VARIANCE REQUEST

1. Date: November 1, 2004	13. Decision:
2. Review Engineer: Satya P. Chennupati	Date:
3. Date Received: October 18, 2004	
4. Facility Name: Wapsie Valley High School	14. Appeal:
5. County Number: 9 (Bremer)	Date:
6. Program Area: CP (Wastewater Construction)	
7. Facility Type : C05 (Biological Treatment)	
8. Subject Area : 308	
9. Rule Reference: 567-64.2(9)a	
10. Design Stds Ref: 14.2.3	
11. Consulting Engr: MMS Consultants Inc.	
12. Variance Rule: 567-64.2(9)c

Subject: Variance Request from IA 14.2.3 & 64.2(3)c IAC 567
Wapsie Valley High School Wastewater system, Bremer County, Iowa

Re: Wapsie Valley High School - Wastewater Treatment System Improvements

A
N
1:200
WAPSIE VALLEY
HIGH SCHOOL

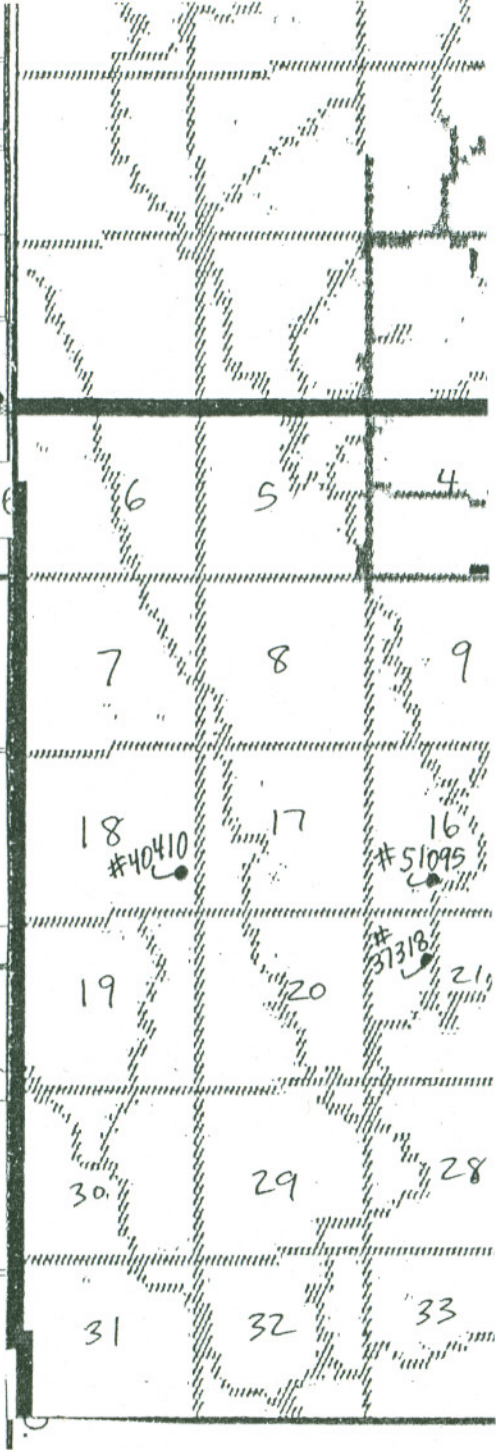
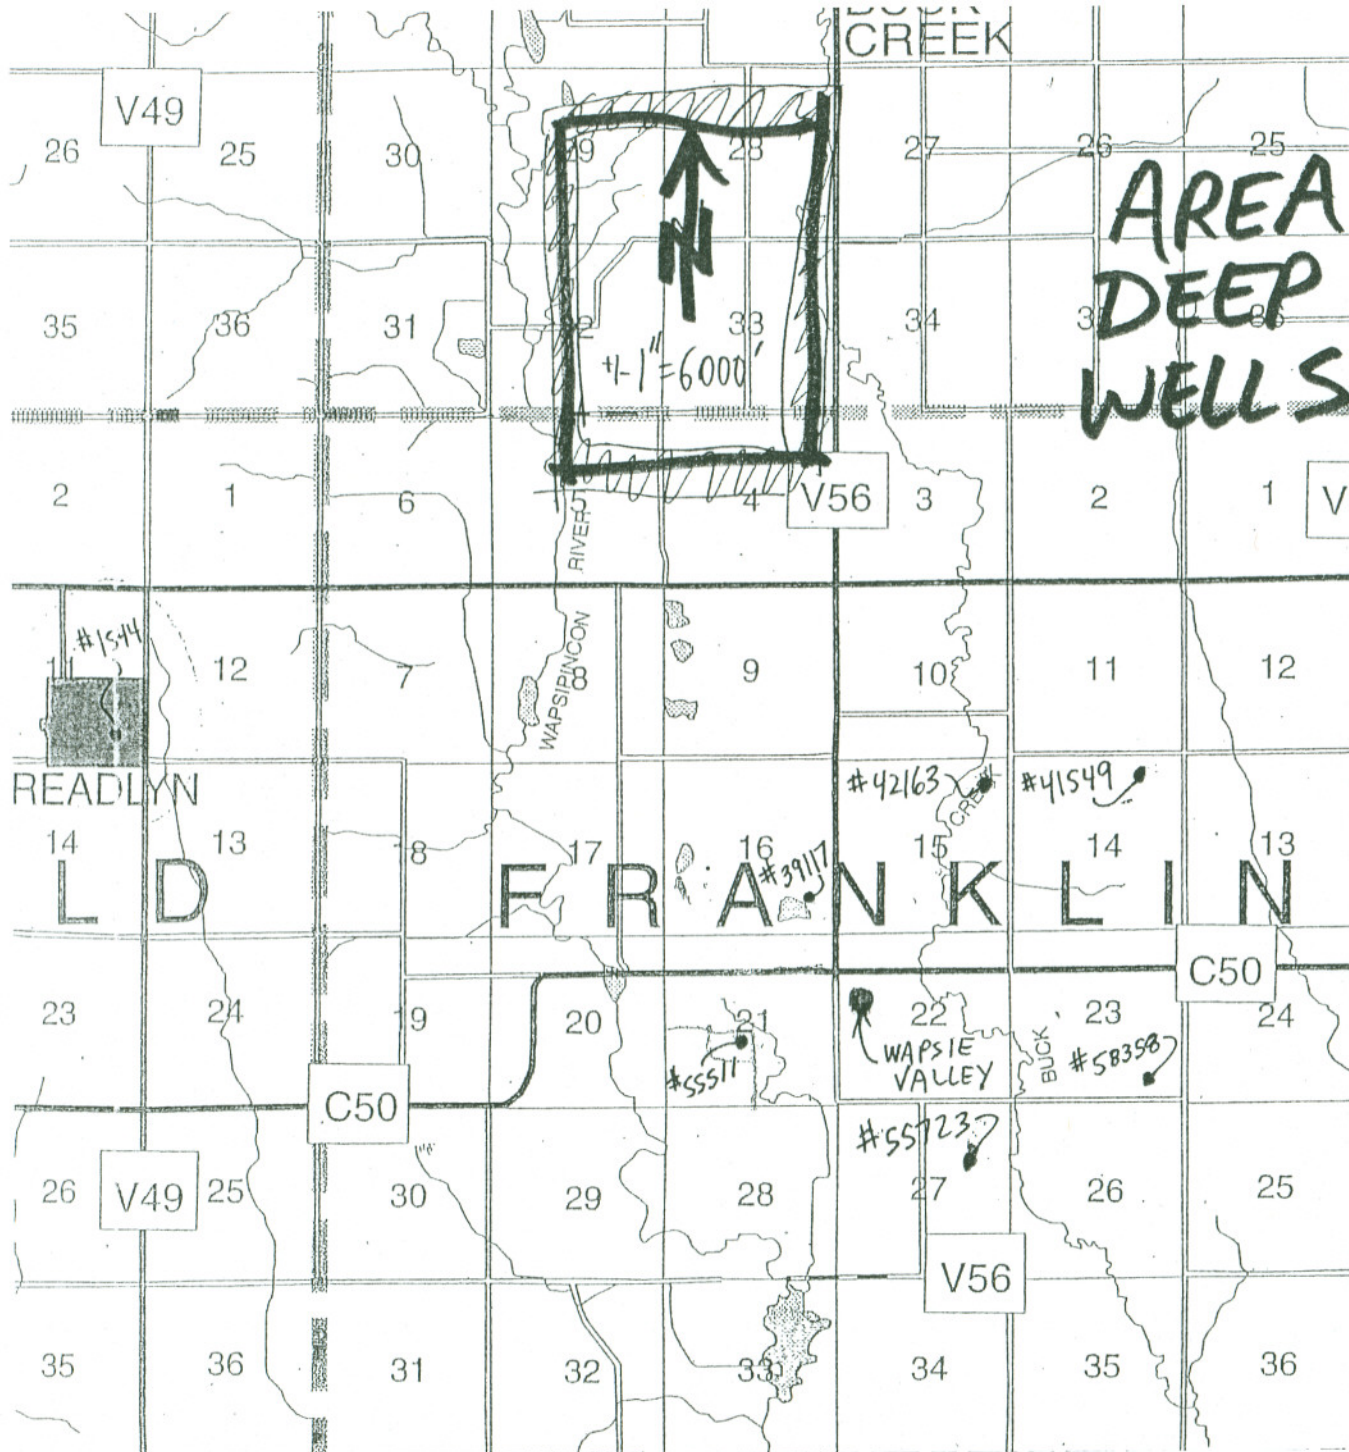
Groundwater moves from east to west towards the Wapsipinicon River. The school well is located east of the existing and proposed treatment sites. Relative to both surface and ground water flow, the well is located upstream of the existing and proposed treatment sites. The attached sketch shows the general movement of surface and groundwater across the site.
